Application by  
Fingal County Council  
for Waste Licence Application W0231-01  
for Fingal Landfill, Co. Dublin

***Replies to Request  
for further information in accordance with  
Article 14(2)(b)(ii) of the Waste  
Management Regulations***

May 2007

Title **Depth to Gravel (mbgl)**

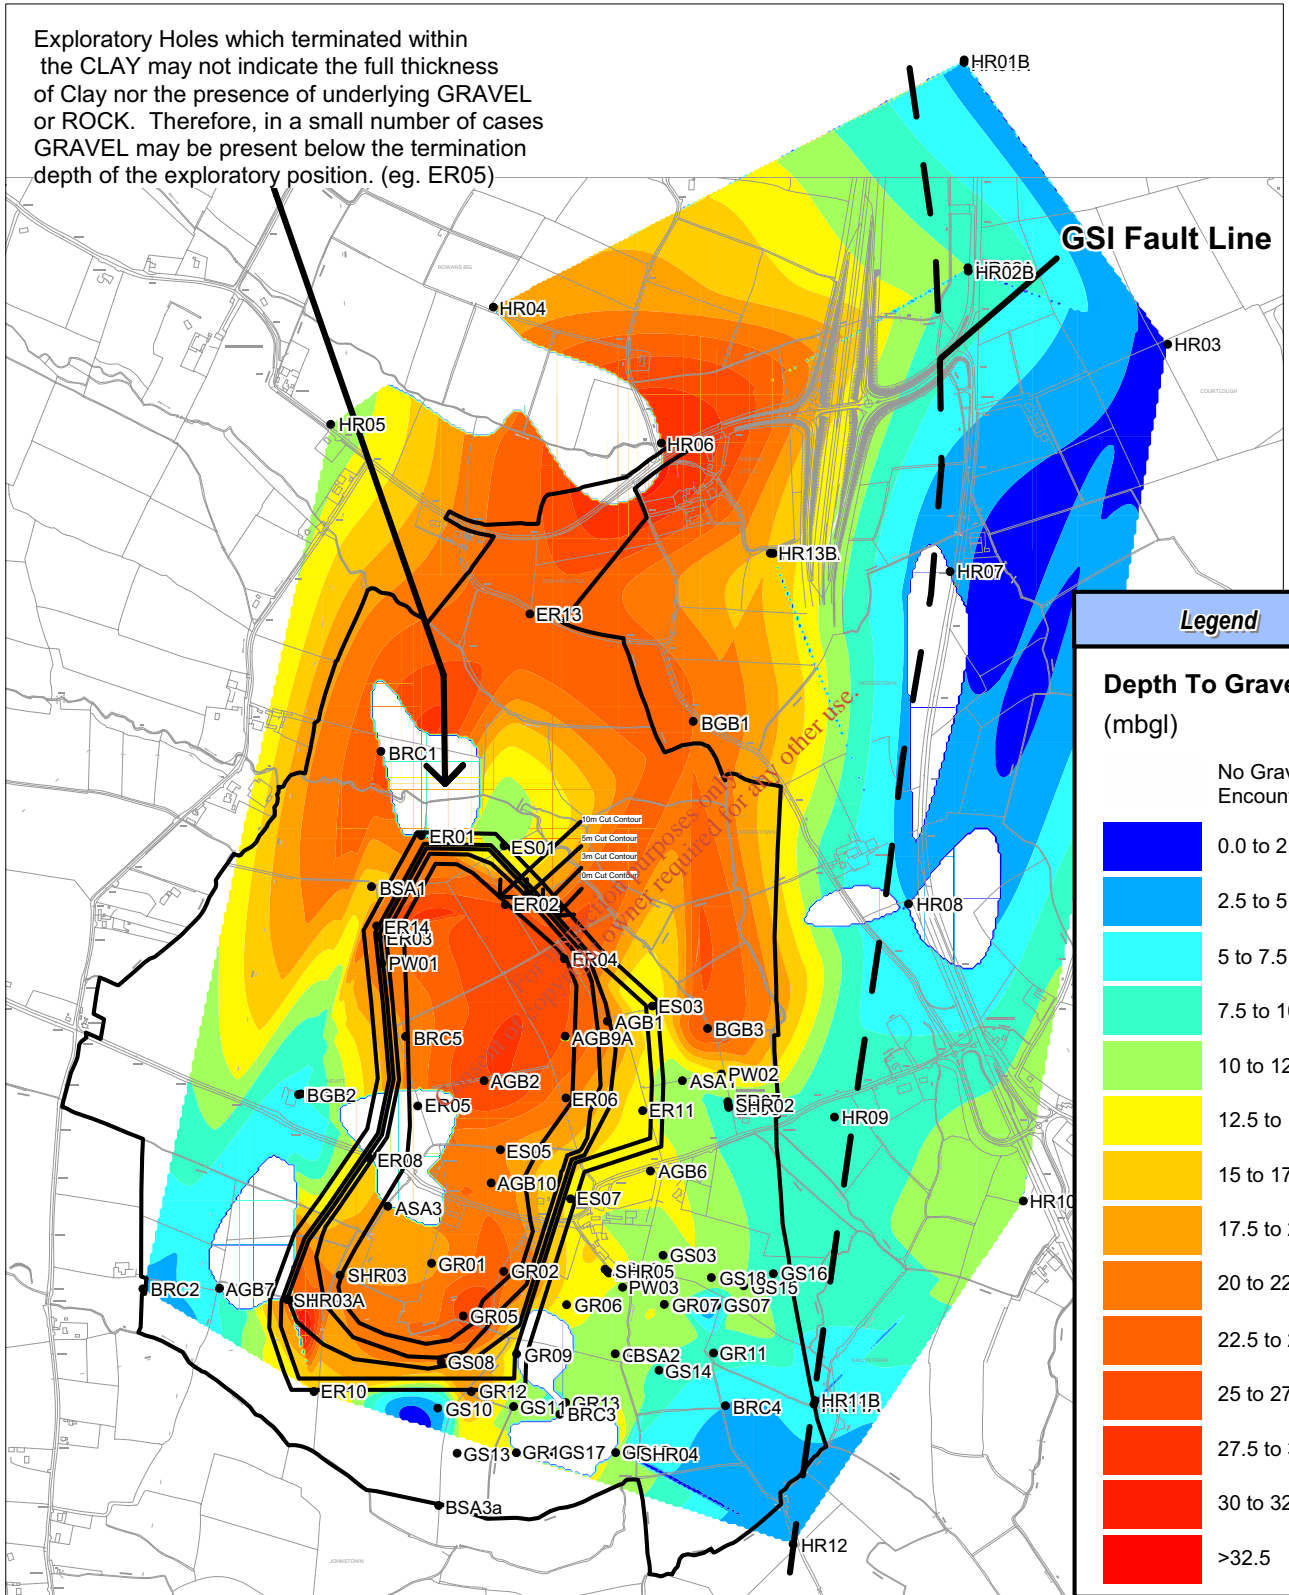
**(ii) Provide a contour map of depth to gravel across the site;**

A contour map of depth to gravel across the site is shown in **Figure 1**.

**Title**  
**Potential Zone of Influence for Hypothetical Boreholes at Yields of 2000m<sup>3</sup>/day and 4000m<sup>3</sup>/day**

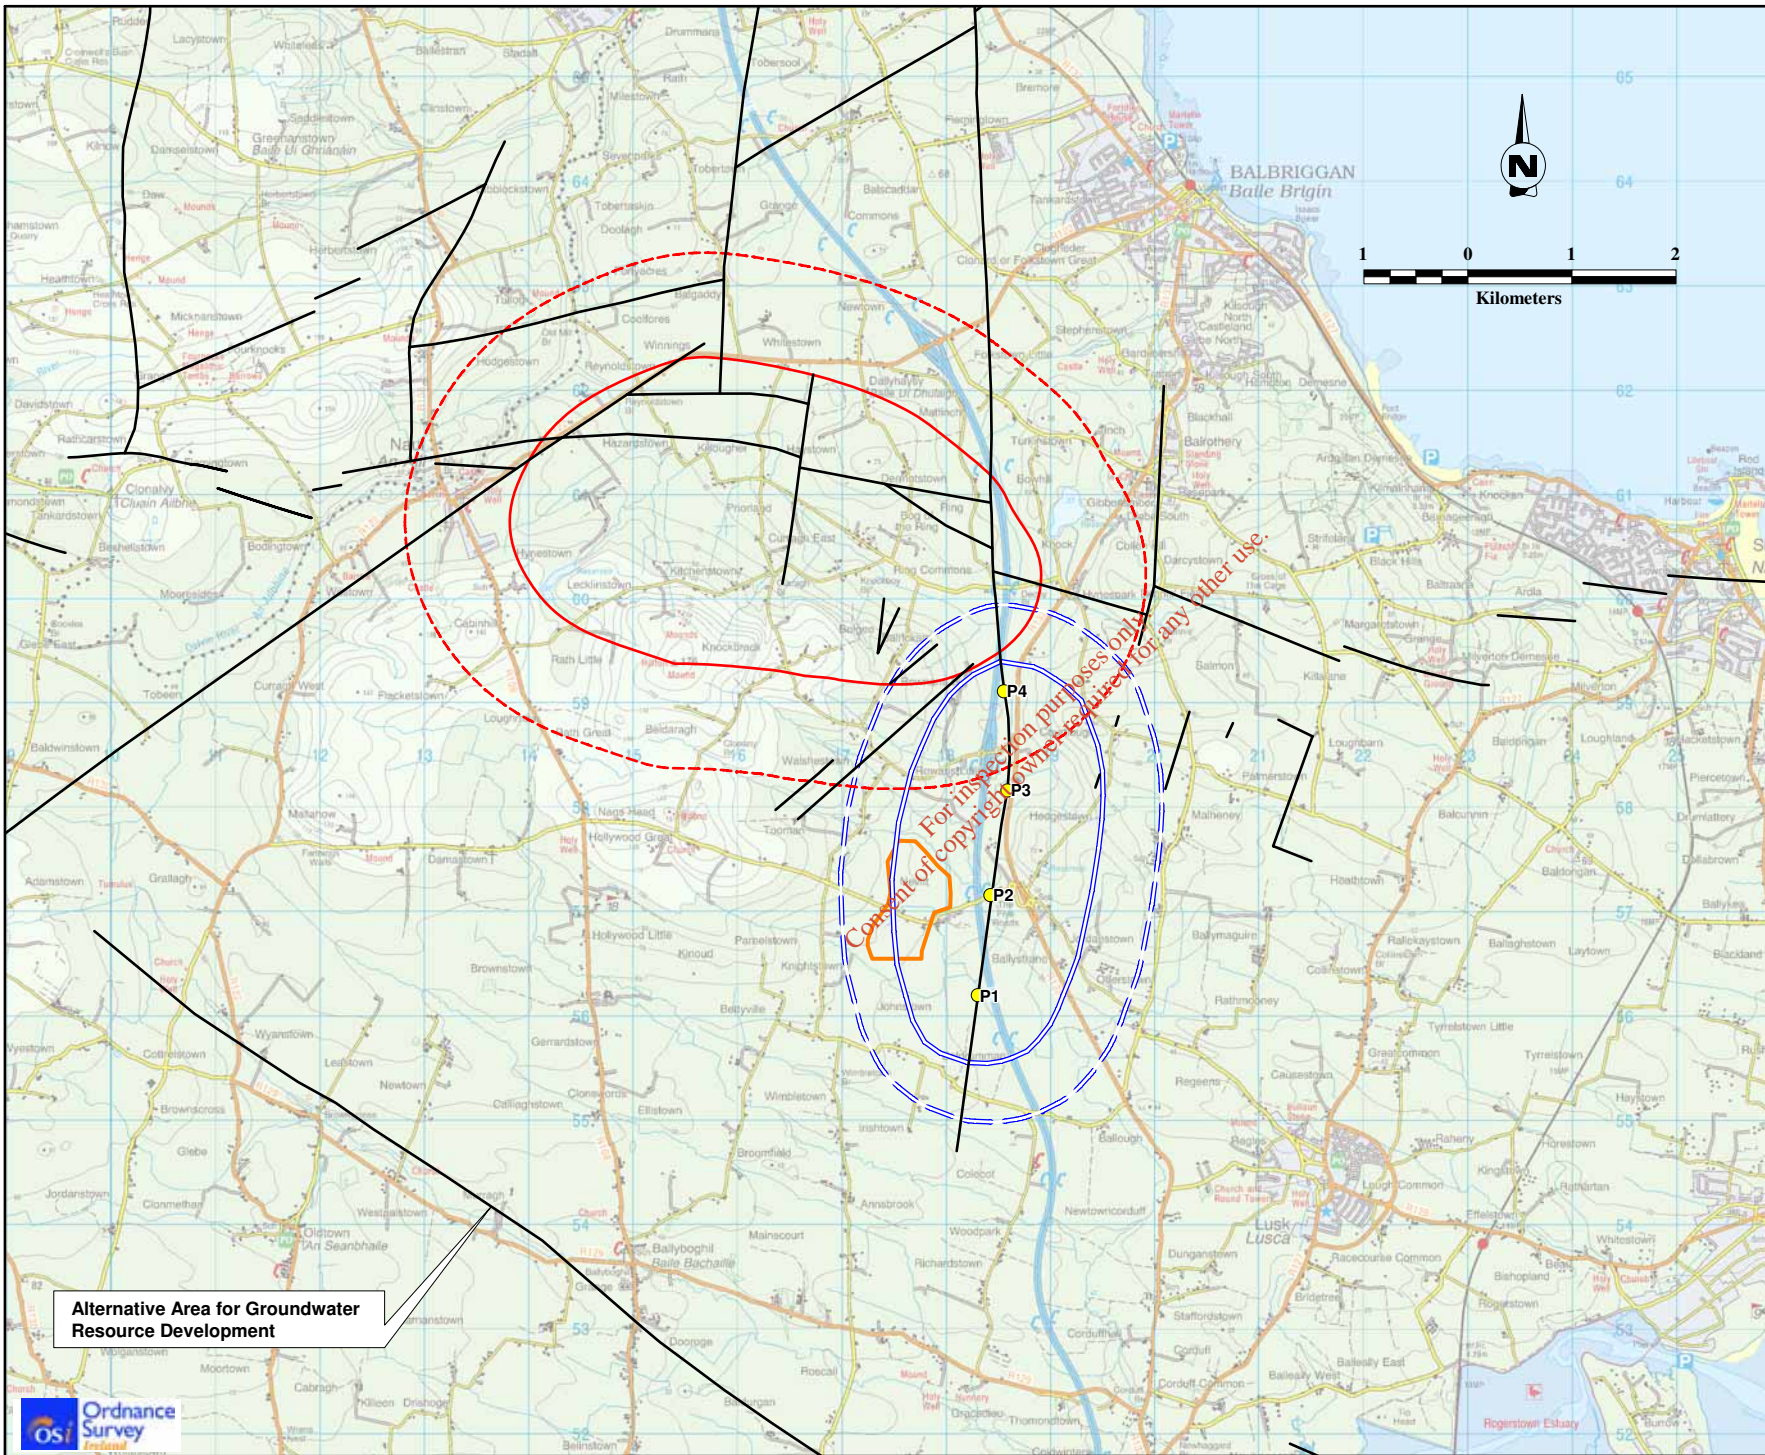
**Point vi:- Based on investigations carried out to date please indicate the potential range of sustainable yields, compared to the existing abstraction rates from the Bog of the ring system, that may be attainable from the area to the south of Decoy bridge. For the maximum and minimum of this range provide a plot of the area of the likely zone of influence.**

Using the recharge rates applied to groundwater abstraction at the Bog of the Ring of 57mm/year for 75% of the area and 322mm/year for 25% of the area, then the minimum and maximum zones of influence of the hypothetical well field is illustrated in **Figure 2**. It is appropriate to apply the same recharge rates to this well field as to the Bog of the Ring well field as the subsoil conditions in the area are similar to that at Bog of the Ring, in that they contain large areas of thick low permeability soils. The rationale of using the same recharge rates as those applied at Bog of the Ring was endorsed by Kevin Cullen in his letter to the EPA dated 30<sup>th</sup> March 2007.

**Figure 2** illustrates that there is potential for interference with the existing zone of influence of the Bog of the Ring scheme and that this would have to be considered if developing a well field in the fault zone south of Decoy Bridge. It may also be feasible to develop a well field further south of Decoy Bridge as indicated in **Figure 3**. Although the north-south fault zone has not been mapped to extend

Figure 4 Groundwater Levels at SHR3a

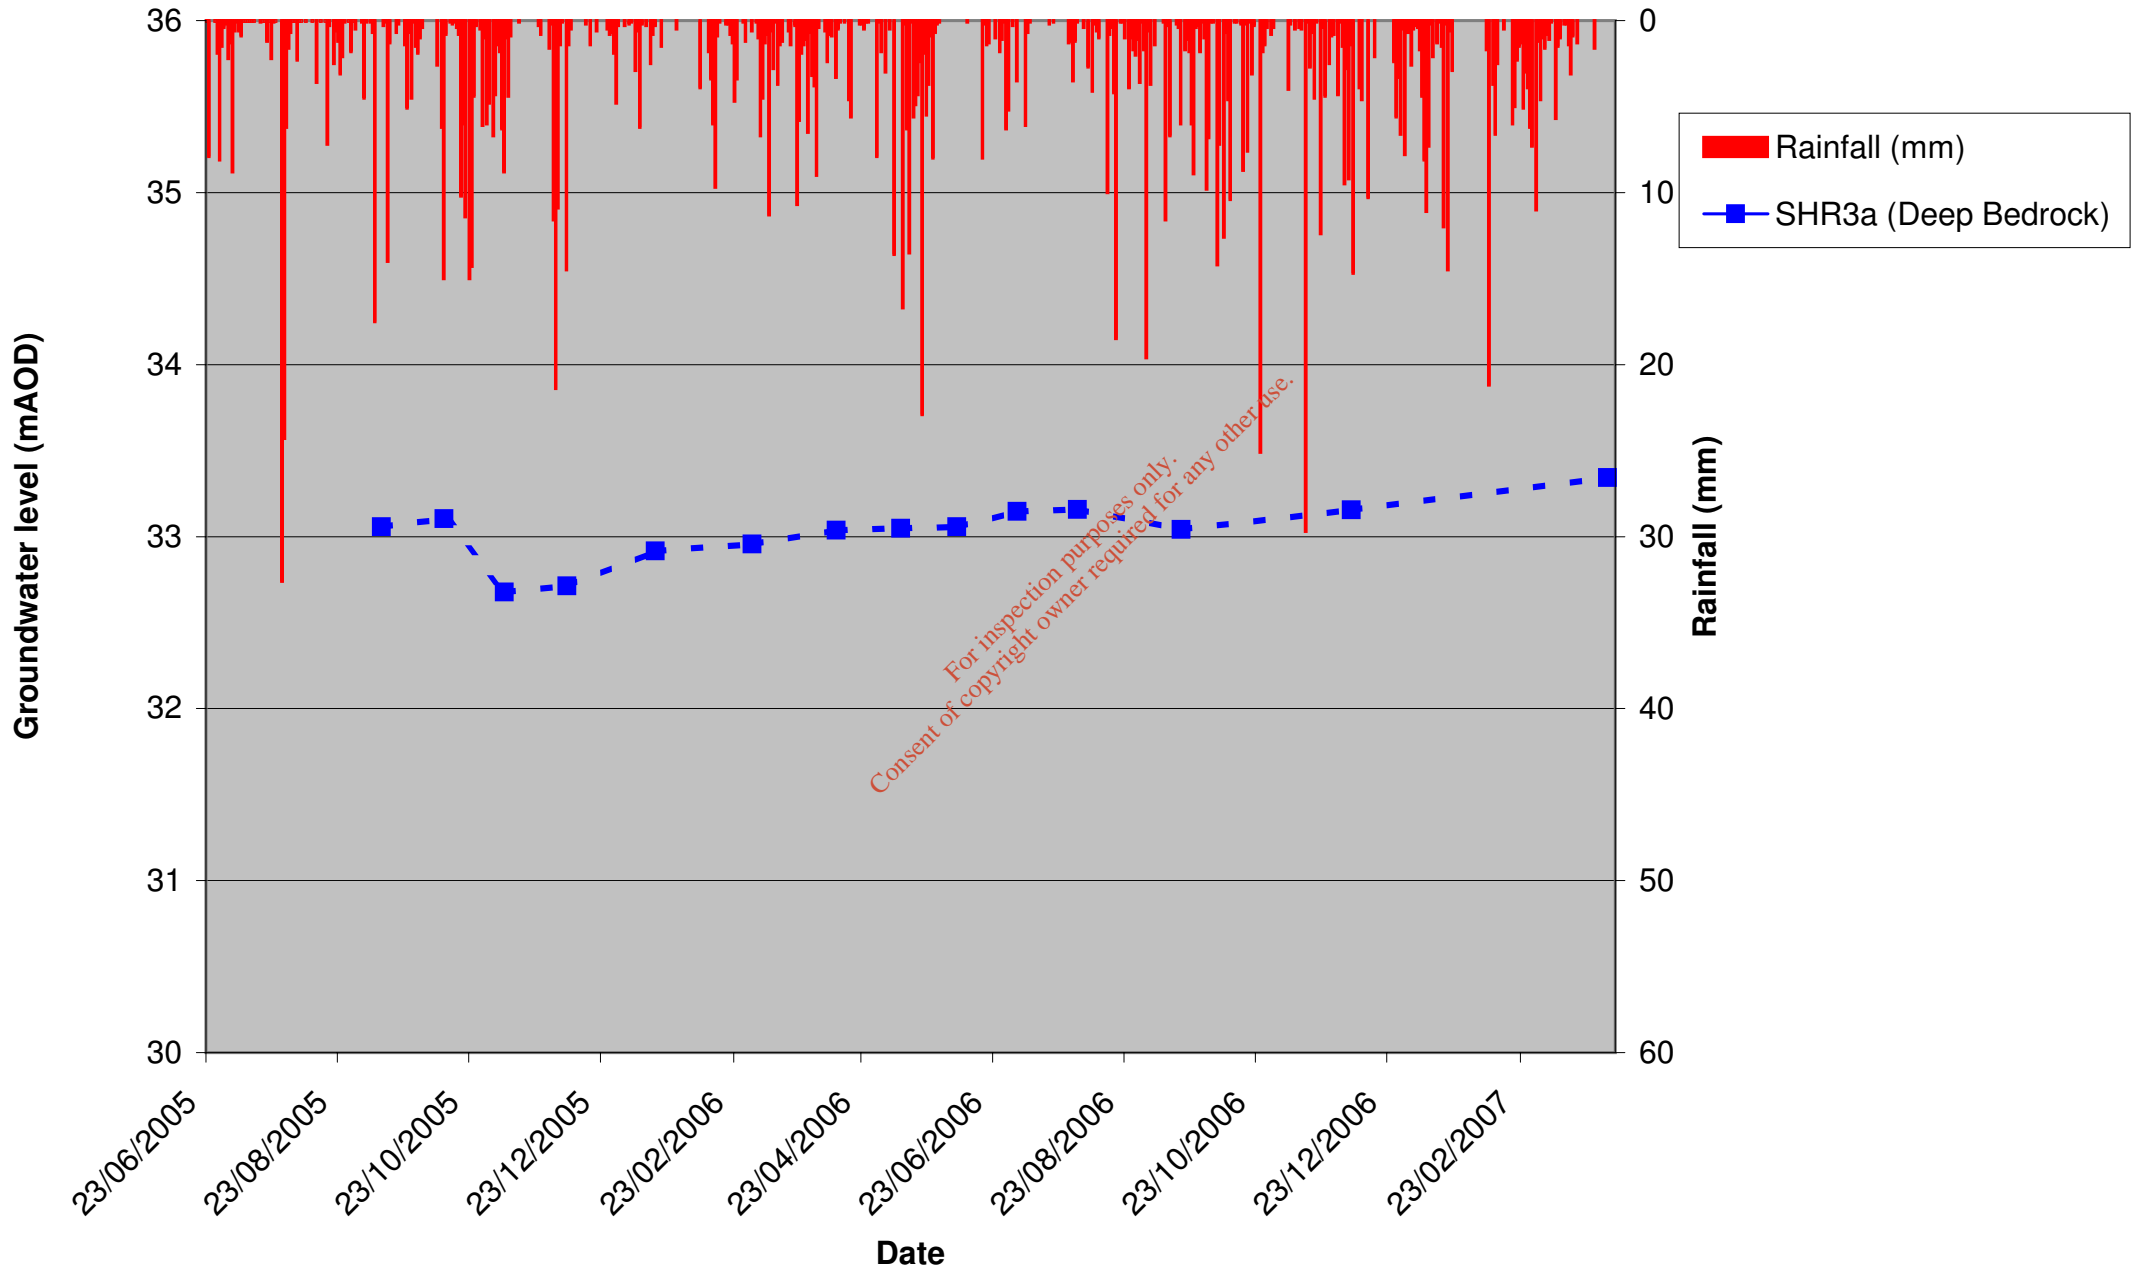
**Appendix 5 – Manual and automated water level data: - Has the applicant identified any specific causes for the variations in water level in bedrock wells ER9 (~ 9 metres) and SHR3A (~ 13 metres)? Please comment on the reported variations. Comment on the impact of these variations on the overall interpretation of the site hydrogeology as detailed in the EIS.**

The variation in water table on the 11<sup>th</sup> of October 2005 is a transcription error. A water table measurement of 20 metres below the top of the casing was entered as metres above ordnance datum resulting in a lower than normal reading. This has now been corrected as shown on the attached graph in **Figure 4**.

There is no change in the interpretation of the hydrogeology in the EIS.

**Title**  
**Groundwater Contours (mAD) Bedrock**  
**3rd April 2007**

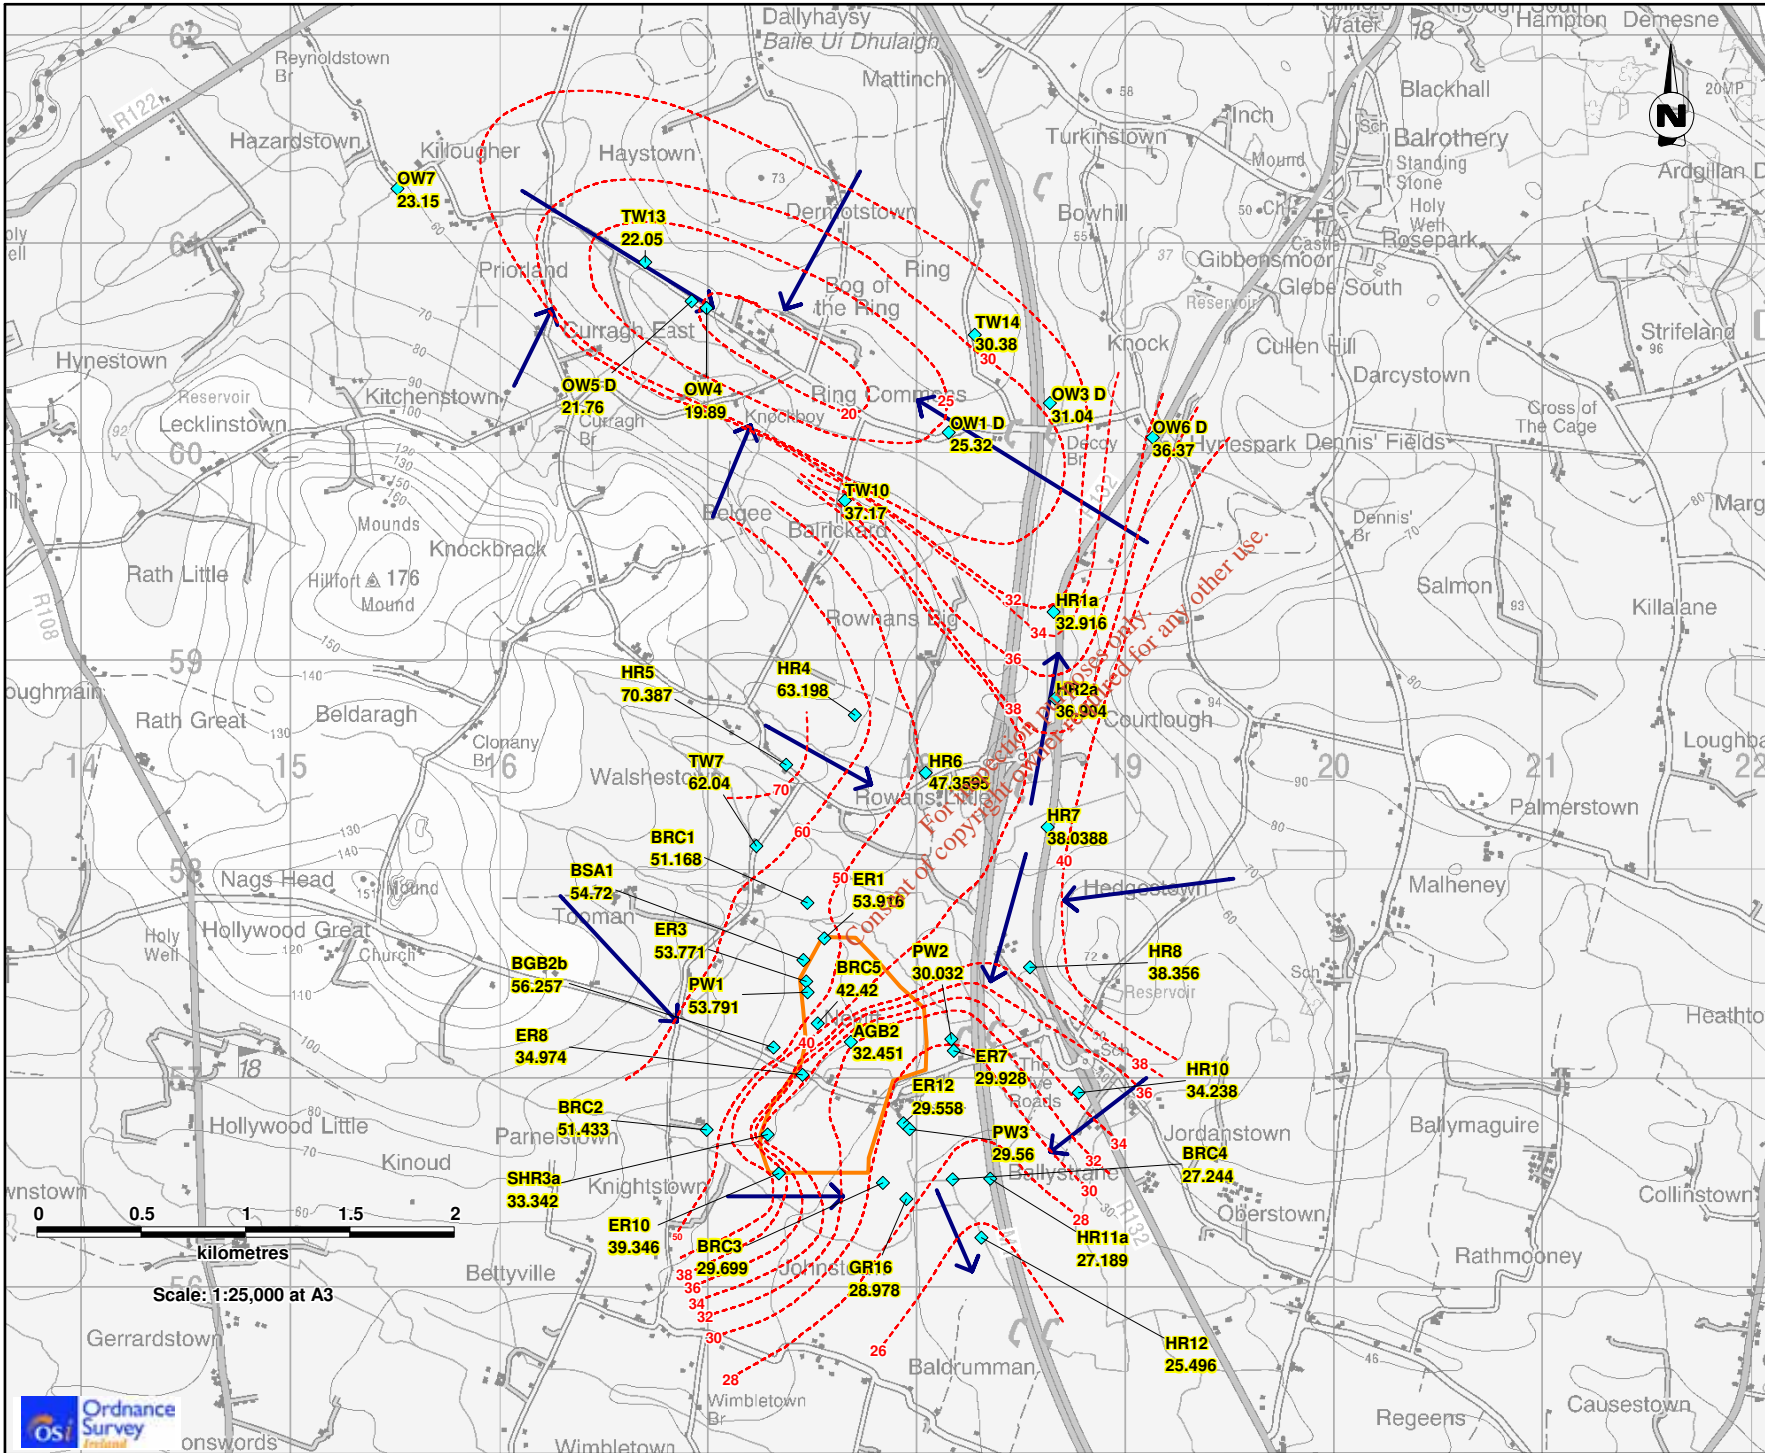
***It is proposed in submissions by Mr. Kevin Cullen (submission No. 78, copy attached) that a significant fault is present beneath the landfill footprint which will significantly impact the groundwater flow beneath the footprint compared to the bedrock groundwater contour maps submitted to date. Please comment on Mr. Cullen's interpretation of the data. Identify any potential risk, with regard to the landfill engineering, associated with reactivation of this fault.***

The north-south fault zone mapped by the GSI is coincident with the general low lying area east of the proposed landfill. Groundwater flow mapping using an extensive monitoring network has consistently demonstrated convergence of groundwater flow in this lowland area as groundwater flows from the elevated ground east and west of the fault into the north south fault zone. RPS therefore do not agree with Mr. Cullen's interpretation that a fault exists below the proposed landfill that would significantly affect the groundwater flow mapping that has been completed. The bedrock groundwater contour maps produced in the EIS and supplied in additional information are an accurate reflection of groundwater flow across the area and are based on actual measurements of the piezometric surface from an extensive monitoring network. This monitoring has extended over a 22-month period to include seasonal variations from June 2005 to present. The April 2007 groundwater flow map is included as **Figure 5** and confirms the previous hydrogeological interpretation of the area.
